MEMORANDUM

Date: May 18, 2021
Project: Collin County ADC DDC Upgrade
To: John Griffin, Collin County
RE: Project Closeout action list

**Punch List**

PROJECT: Collin County Upgrade

Electrical Room

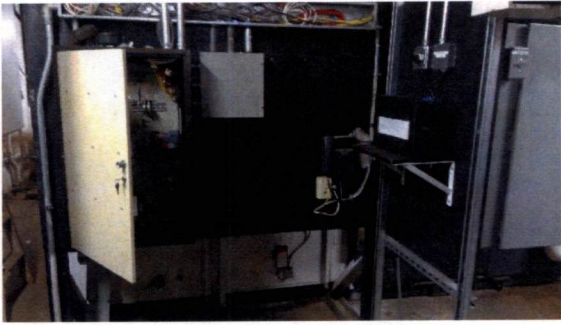
- Provide power to existing panel from UPS.
- Label Panel

01 SECOND FLOOR OVERALL PLAN - BUILDING H

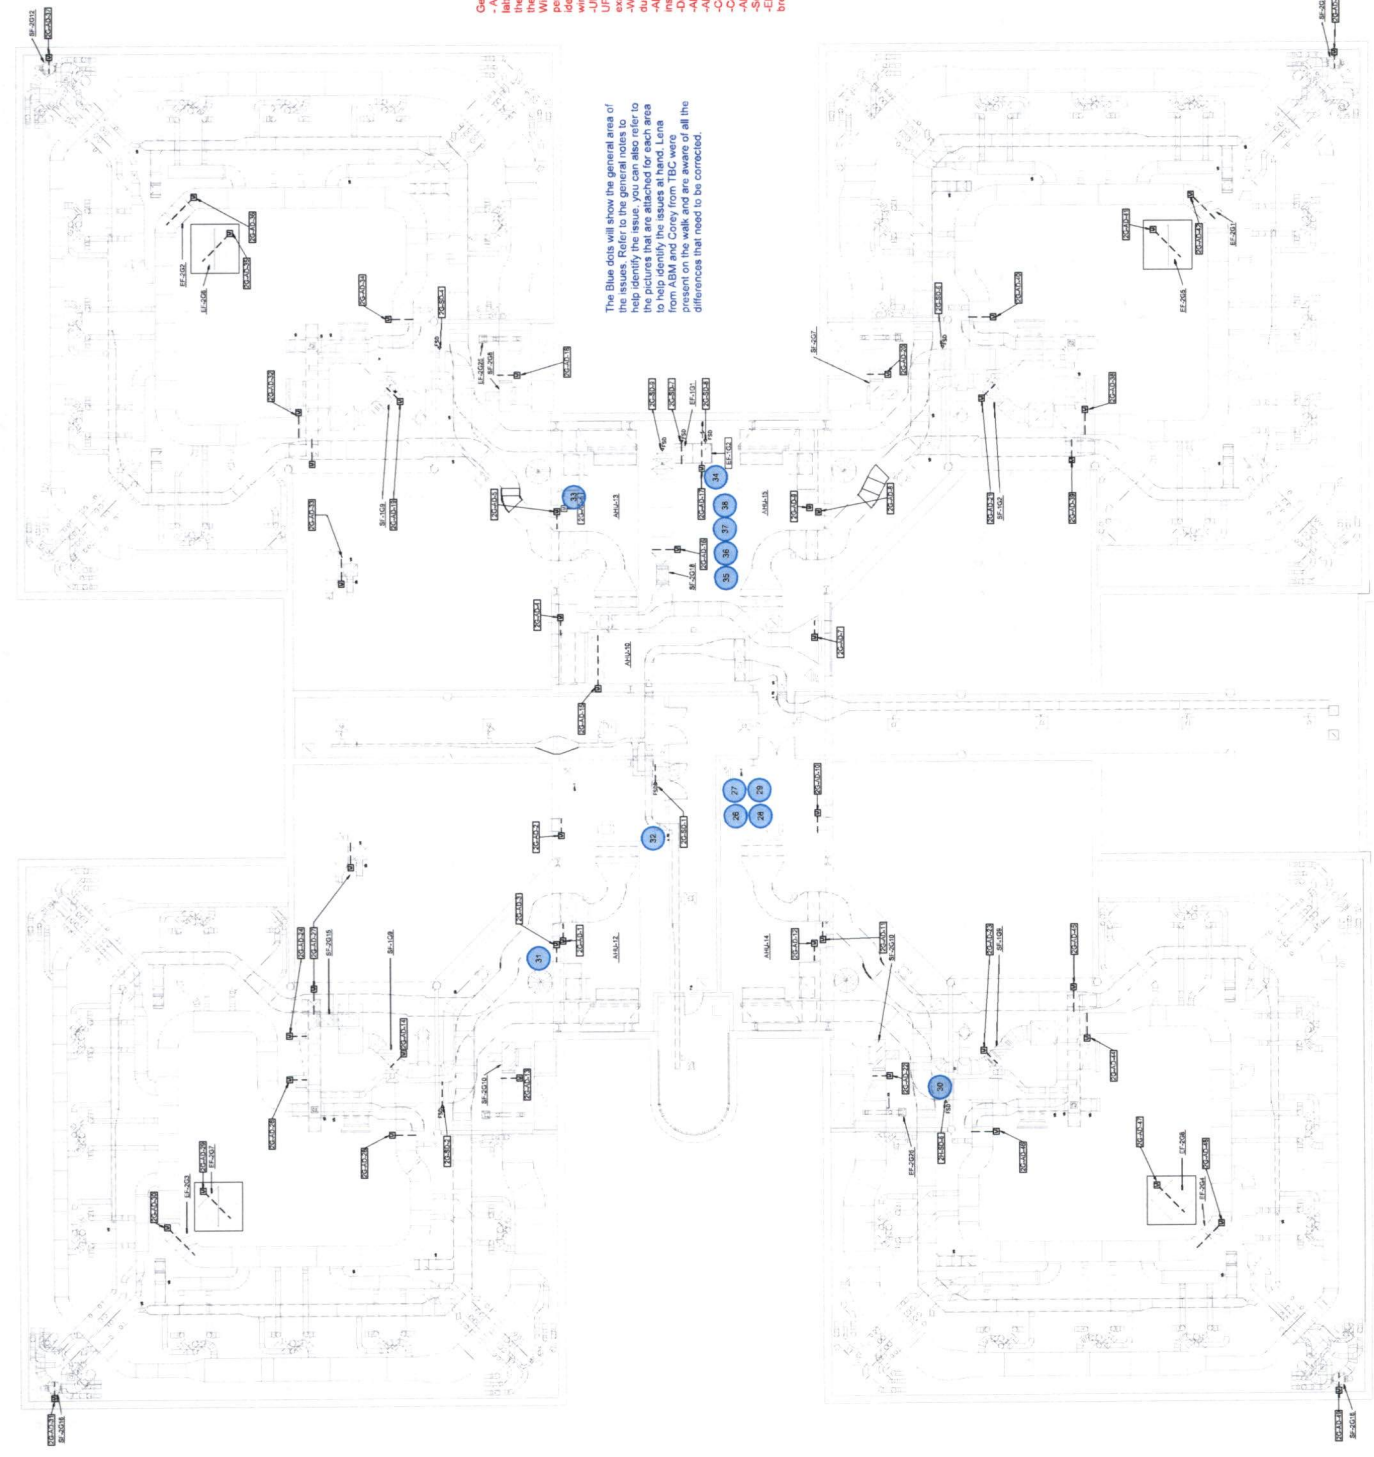
General Notes for All Areas:

- All panels, J-boxes, disconnects, and wiring needs to be labeled with labels not black ink or pen per the specification. Some actuators have the labels on the back of them and you are unable to see them, label the J-box they go to for better identification not in black ink or pen. If you can't see the label, label it with a black ink or pen. Some areas not labeled at all, the service techs need to be able to identify which wire goes to which actuator without having to trace the wire all the way back to the actuator.

- All wiring needs to be labeled with what areas it is serving. The UPS needs to have power run to the existing panels. Use area E as an example or coordinate with Brad.

- Wiring Diagram needs to be in a clear protective sleeve and not ducted taped to the back of the door.
- All wiring needs to be pickup and panels need to be cleaned on the inside.

- Demo is not complete of existing Pneumatic controls.
- All panels and J-boxes are to have covers on them.
- All wiring needs to be labeled with what areas it is serving.

- Conduit is not supported to unsuit.
- All Conduit to be 1" minimum.
- Screws on plywood are sticking out causing a possible safety issue. All plywood needs to be replaced with 1/2" plywood with pen. New breaker was not supplied for new incoming power.

The Blue dots will show the general area of the issue. Review the notes to help identify the issue. You can also refer to the pictures that are attached for each area to help identify the issues at hand. Lena is present on the walk and aware of all the differences that need to be corrected.

01 BUILDING 19 SECOND FLOOR PLAN AREA B - MECHANICAL AND ELECTRICAL
SCALE: 1/8" = 1'-0"

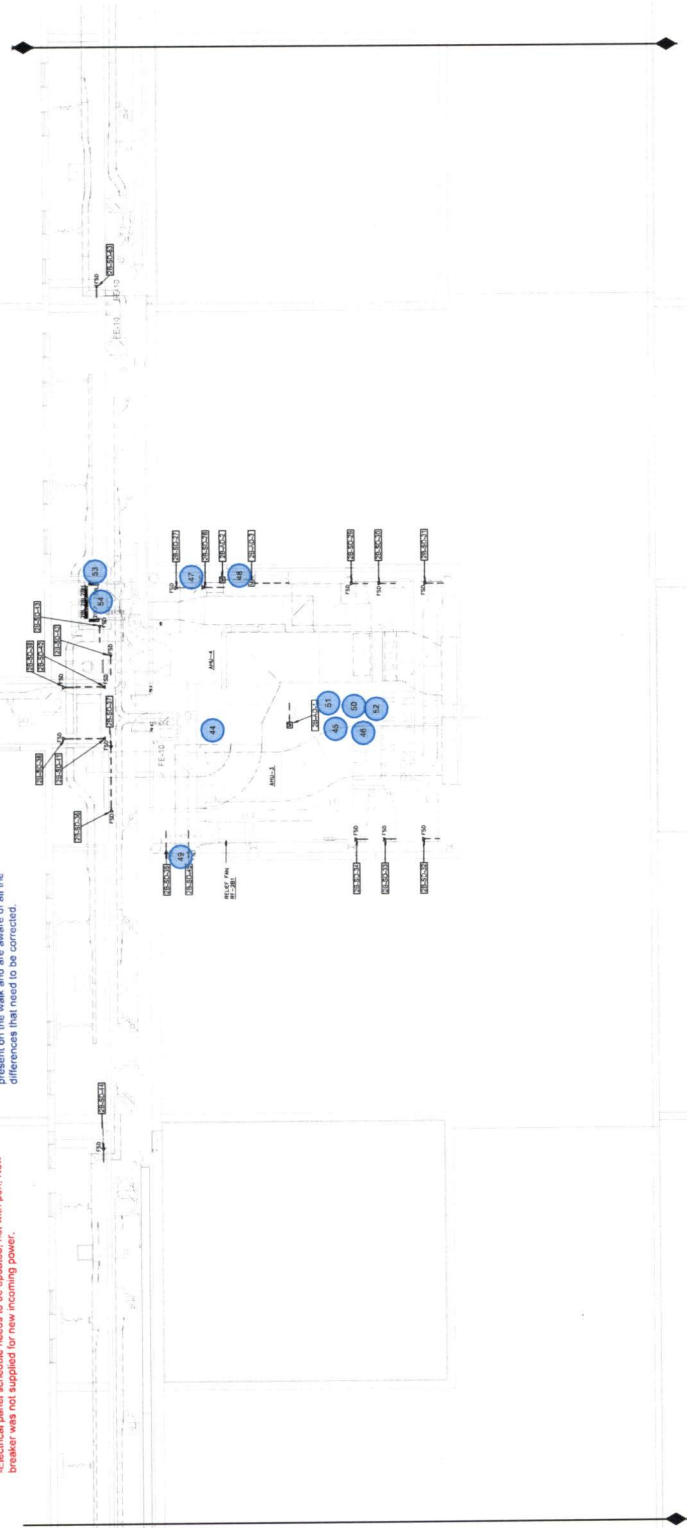
- General Notes for All Areas:
- All panels, J-boxes, Disconnects, and wiring needs to be labelled with labels not black ink or pen per the specification. Some actuators have labels not black ink or pen per the specification. Some actuators have labels not black ink or pen per the specification. Some actuators have labels not black ink or pen per the specification.

- Wiring inside the panels need to be labelled with labels not black ink or pen, some areas not labelled at all. The service techs need to be able to identify which wire goes to which actuator without having to trace the wire.

- UPS needs to be labelled and identify what areas it is serving. The UPS needs to have power ran to the existing panels. Use area E as an example or coordinate with Brad.

- All trash needs to be picked up and panels need to be cleaned on the inside.
 - Cable is not complete of existing pneumatic controls.
 - All panels and J-boxes are to have covers on them.

- Conduit penetrating walls or floors are to be sealed.
 - Conduit is not supported or unsuited.
 - Screws on plywood are sticking out causing a possible safety issue.

- Electrical panel schedule needs to be updated, not with pen. New breaker was not supplied for new incoming power.

The Blue dots will show the general area of the issues. Refer to the general notes to help identify the issue. You can also refer to the pictures that are attached for each area to help identify the issue. The pictures are from KBM and Corey from TSC were present on this walk and are aware of all the differences that need to be corrected.
